ADDENDUM NO. 2

Project: Sabinetown Recreation Area - RFB 25-1202

Project No.: SRA23985

Addendum Date: August 8, 2024

2 SLAB SAW CUT CONTROL JOINT (SJ)

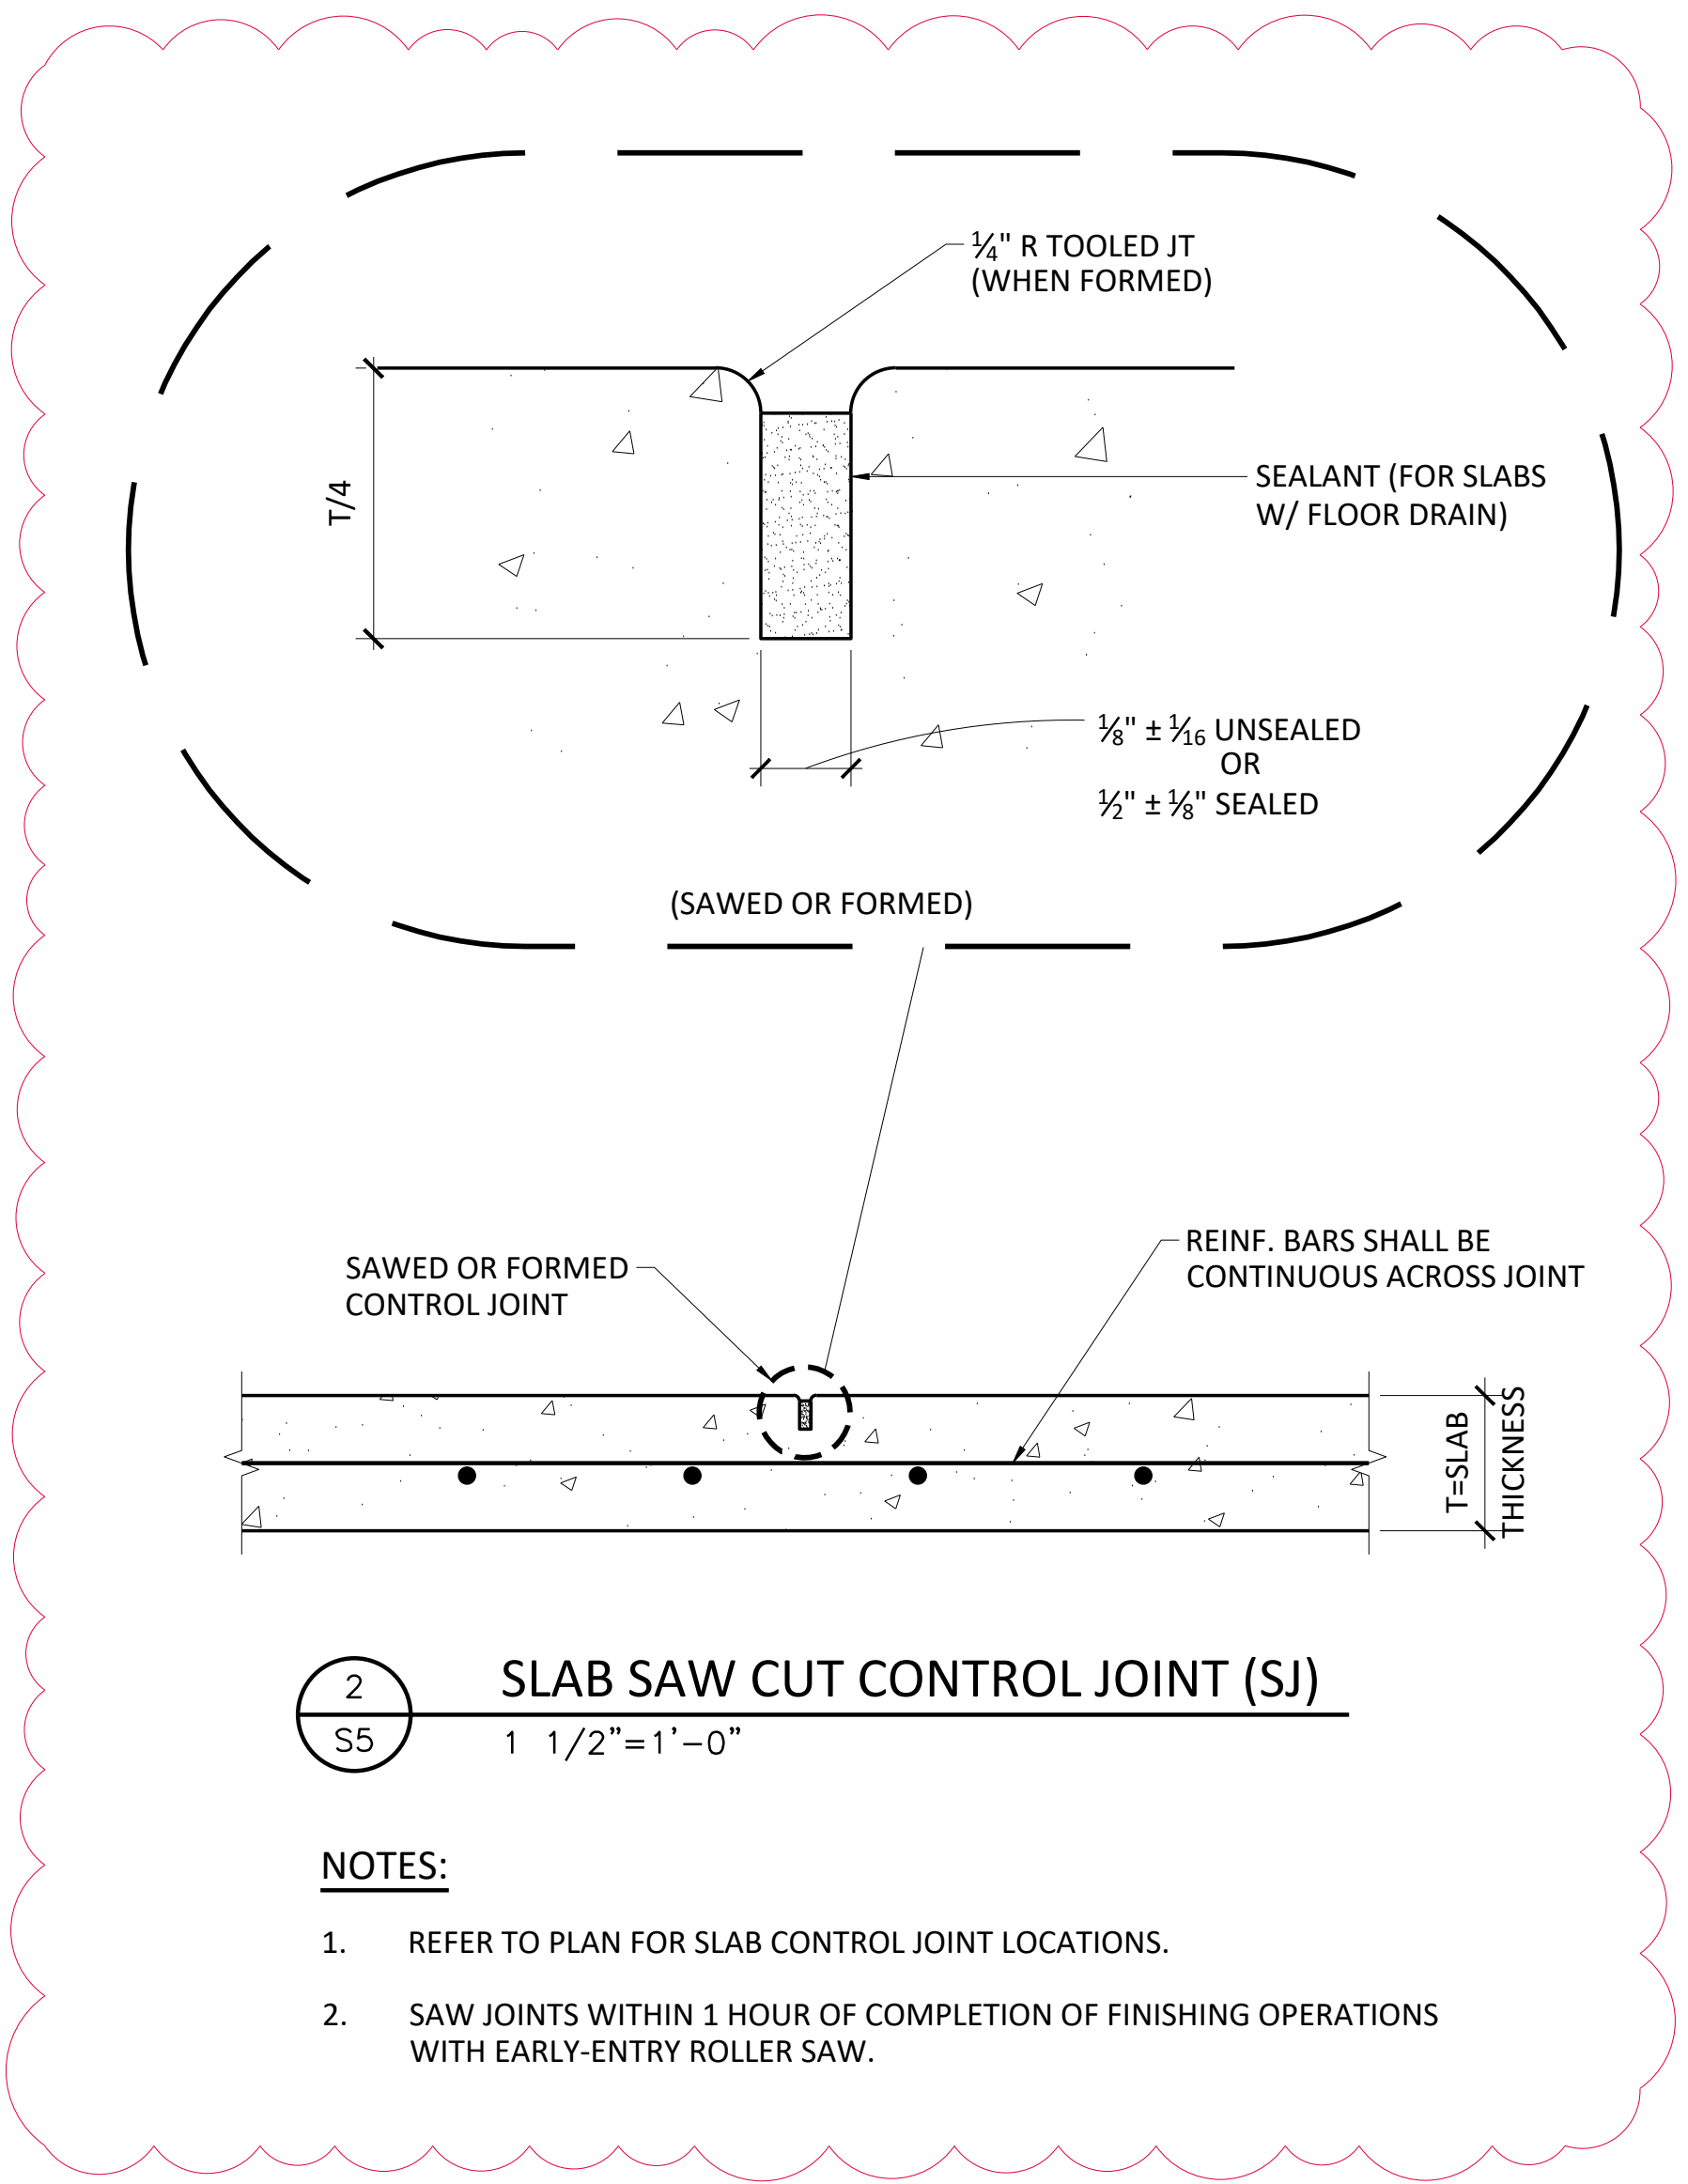
10. Question: Will Aquafin or a similar product be used in concrete for waterproofing at the boat ramp or any other areas?
 - a. **ANSWER: NO.**
11. Question: On the boat ramp are you wanting plate dowels at the saw joints? Where is the saw joint detail for the boat ramp? Where does it specify reinforcing in the flat part of the boat ramp?

- a. **ANSWER: 1) NO PLATE DOWELS AT THE SAW JOINTS. 2) A NEW SAW JOINT DETAIL WAS ADDED TO SHEET S5 AS PART OF ADDENDUM NO. 2. 3) THE BOAT RAMP REINFORCING WAS ADDED TO SHEET S5 AS PART OF ADDENDUM NO. 2.**

3 MONUMENT SIGN - PLAN VIEW
 L1 NTS

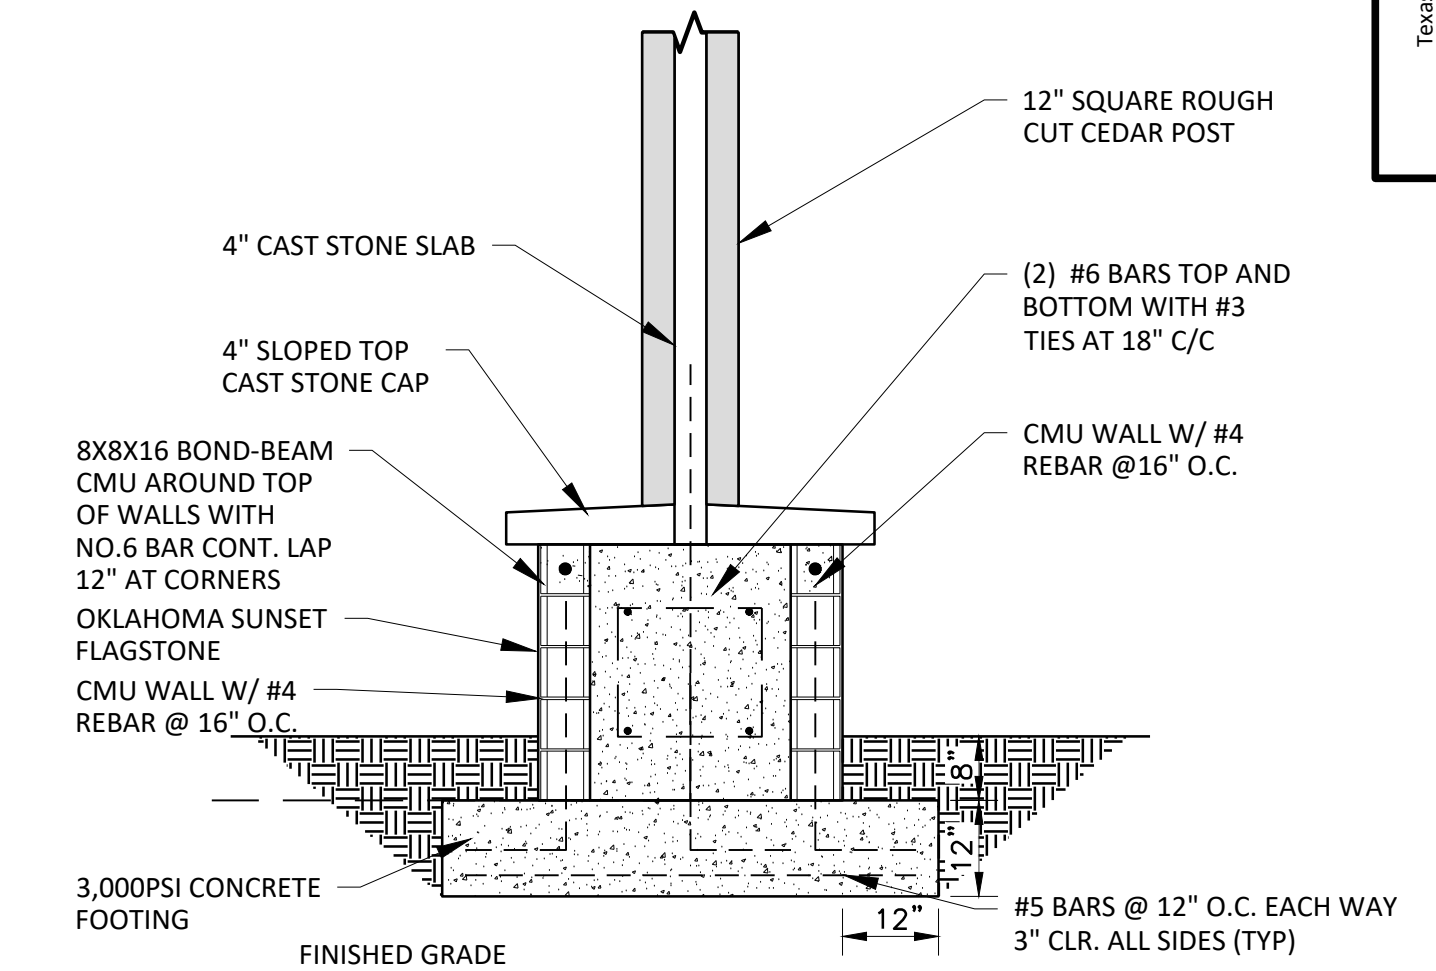
8. Question: On Page L1 Detail 3 shows 4" flag stone slab & Detail 6 shows 4" cast stone slab. Can you clarify and give specs and details?
 - a. **ANSWER: DETAIL 3/L1 SHOULD READ – "CASTSTONE", NOT FLAGSTONE. SPECIFICATION 04 72 00 – CAST STONE MASONRY IS ATTACHED TO THIS ADDENDUM.**
